Project	<b>IEEE 802.16 Broadband Wireless Access Working Group</b> < <a href="http://ieee802.org/16">http://ieee802.org/16</a> >
Title	<b>Amendment to Idle Mode Service Primitives</b>
Date Submitted	<b>2007-03-1409</b>
Source(s)	Jeehyeon Na, Jaesun Cha, JungMo Moon and Sangho Lee <a href="mailto:jhna@etri.re.kr">jhna@etri.re.kr</a> ETRI 161 Gajeong-dong, Yuseong-gu Daejeon 305-700 Korea
Re:	Contribution on comments to IEEE 802.16g/D8
Abstract	Re-definition of Idle mode service primitives in section 14.2.4.2
Purpose	Adoption
Notice	This document has been prepared to assist IEEE 802.16. It is offered as a basis for discussion and is not binding on the contributing individual(s) or organization(s). The material in this document is subject to change in form and content after further study. The contributor(s) reserve(s) the right to add, amend or withdraw material contained herein.
Release	The contributor grants a free, irrevocable license to the IEEE to incorporate text contained in this contribution, and any modifications thereof, in the creation of an IEEE Standards publication; to copyright in the IEEE's name any IEEE Standards publication even though it may include portions of this

Figure 479—Subscriber mode transition diagram at NCMS ([on BS or MS side](#))

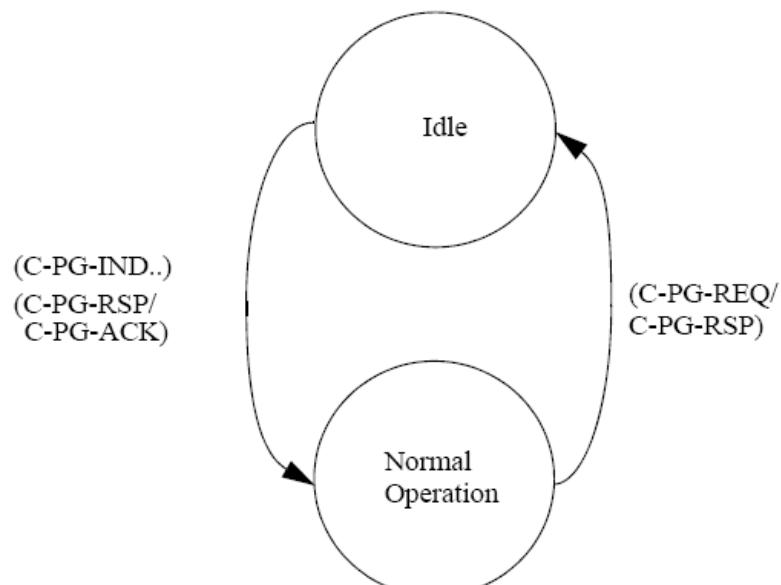
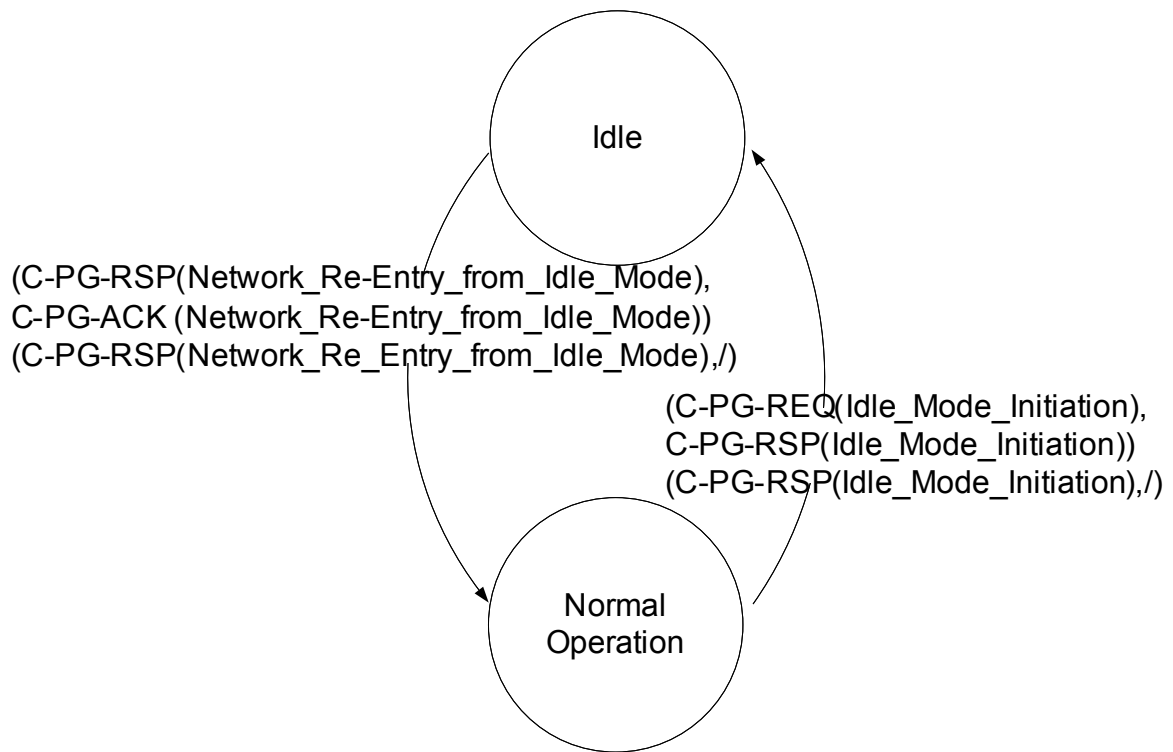
Subscriber mode management is described as informative in section 14.2.4 and it is managed at an MS, a BS and an NCMS. Figure 479 which shows subscriber mode transition diagram at an NCMS is not clear whether for an NCMS on a BS and an MS side or not.

Therefore, we clarify figure 479 and the related texts in order to be used both NCMS at an MS and a BS side.

Figure 479 shows Subscriber Mode transition diagram at the NCMS with service primitives related with the Subscriber Mode transition. Subscriber Mode transition from Normal Operation to Idle Mode is performed by exchanging C-PG-REQ and C-PG-RSP between ~~a BS~~ an 802.16 entity and the NCMS after successful DREG-REQ message from the MS with De-Registration Request Code=0x01 or DREG-CMD message from the BS with Action Code = 0x05, where C-PG-REQ and C-PG-RSP are defined in 14.2.4.2.1 and 14.2.4.2.2, respectively. Subscriber Mode transition from Idle Mode to Normal Operation is initiated after exchanging ~~C-PG-IND~~, C-PG-RSP, and C-PG-ACK between an 802.16 entity ~~BS~~ and the NCMS, where ~~C-PG-IND~~, C-PG-RSP, and C-PG-ACK are defined in ~~14.2.4.2.4~~, 14.2.4.2.2, and 14.2.4.2.3, respectively.

Figure 480 – Idle mode initiation (NCMS on the MS side)

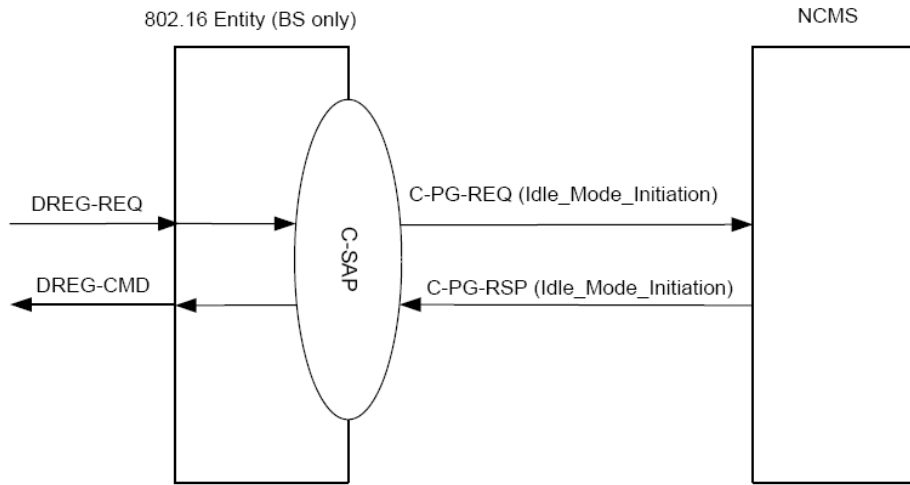
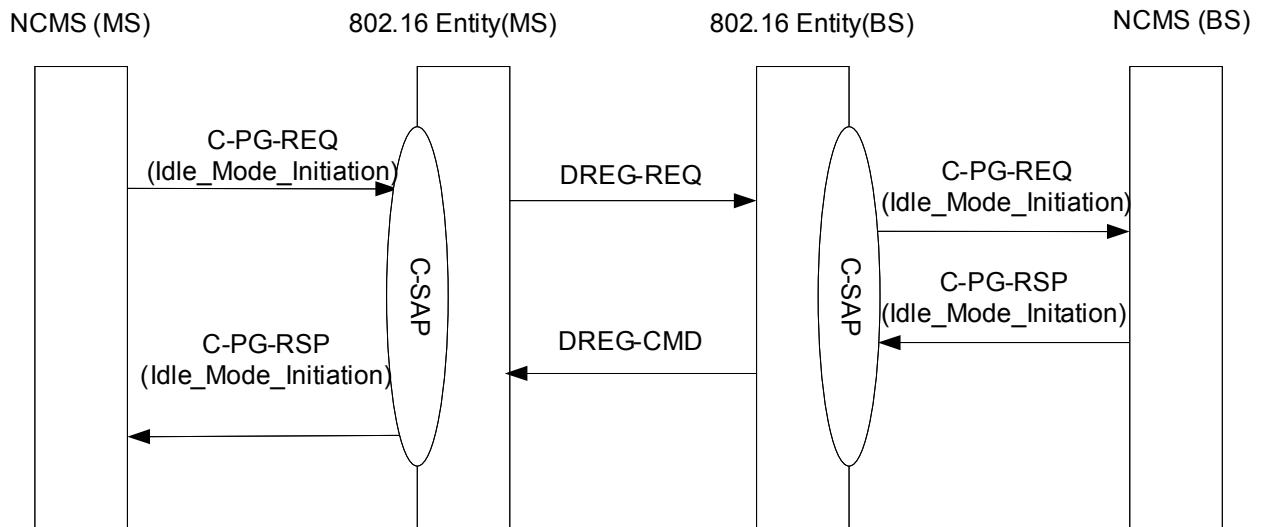
Therefore, we propose to change figure 480, 482, 483 to the figures which are included the service primitives between an 802.16 entity (MS) and an NCMS on the MS side and modify the related service primitives parameters in this contribution. And we also correct some editorial texts.

[Change the figure 480 and its title to as follows]

Figure 482- Paging Announcement

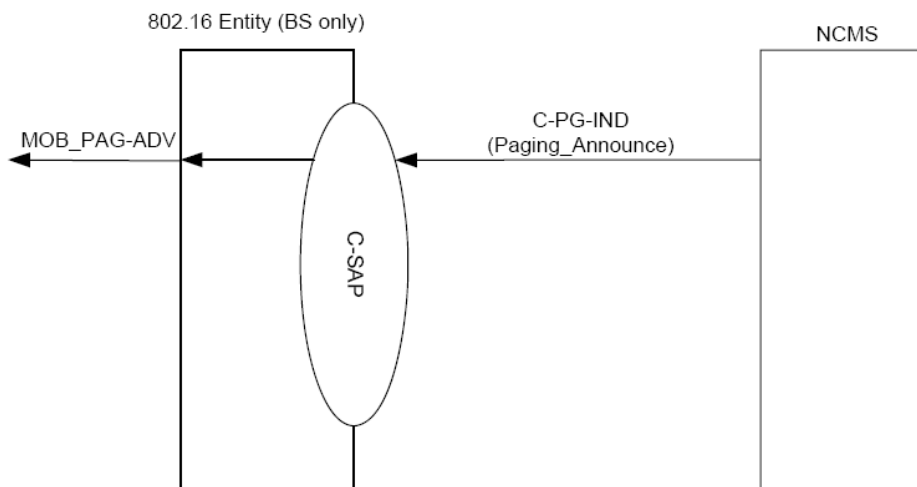
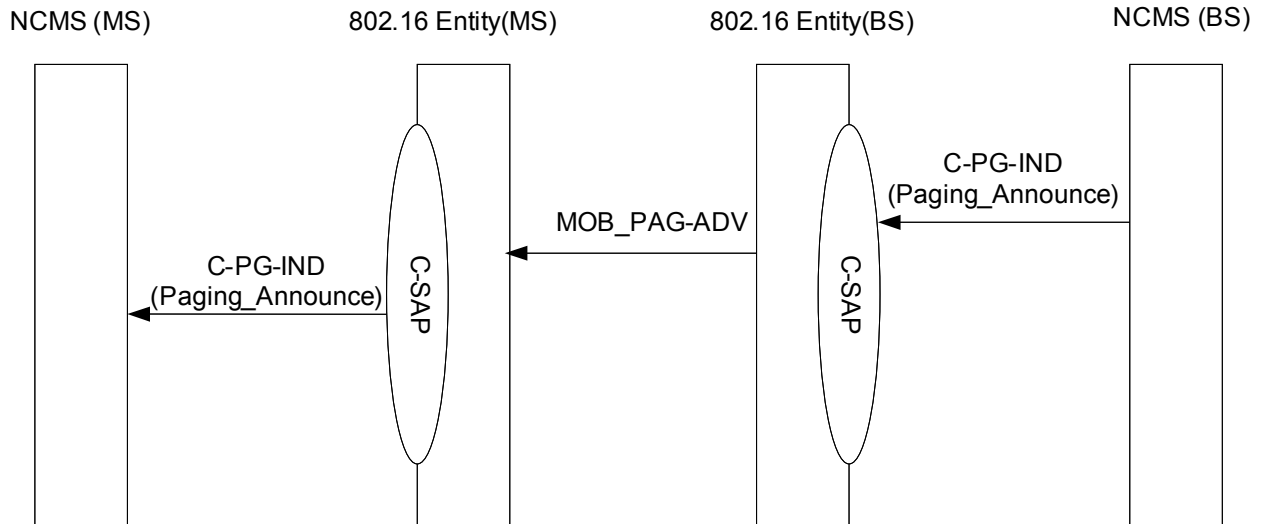
[ Change the figure 482 to the following figure Section 14.2.4.2 ]

Figure 483- Network re-entry from Idle mode primitives

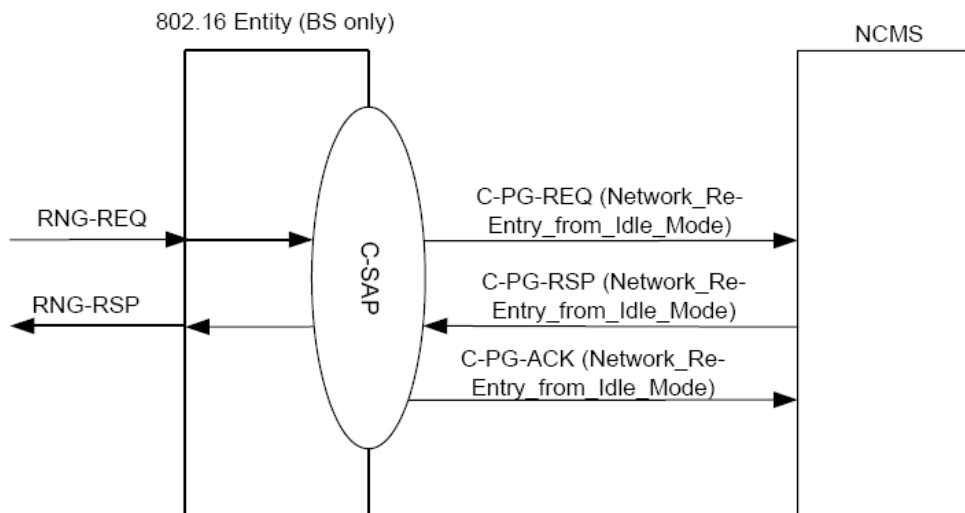
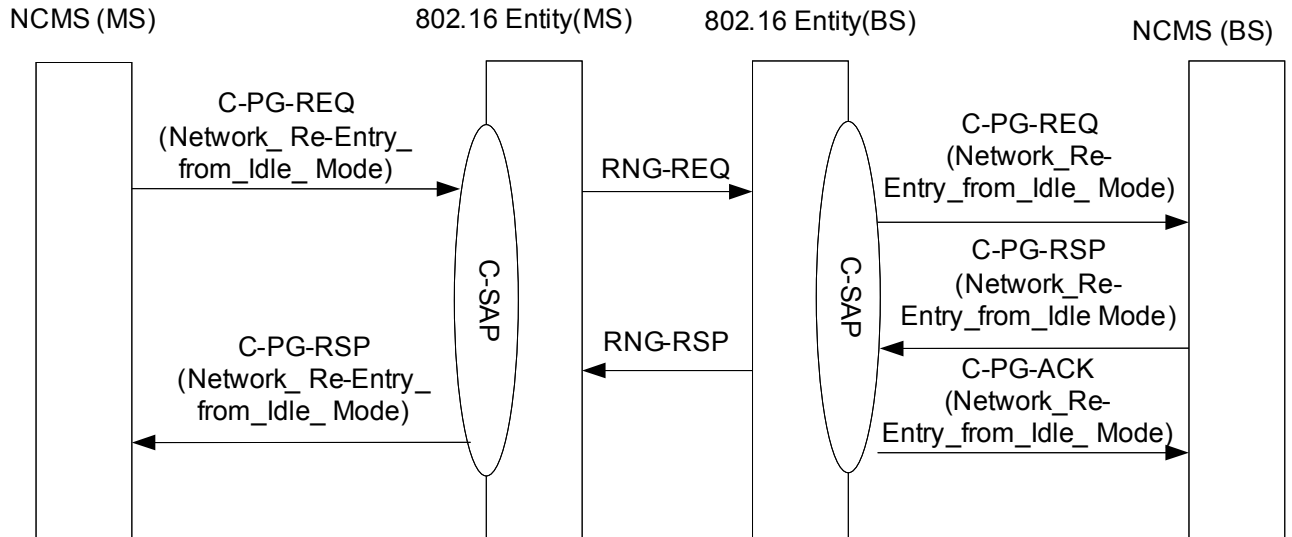
[Change the figure 483 to the following figure in 14.2.4.2]
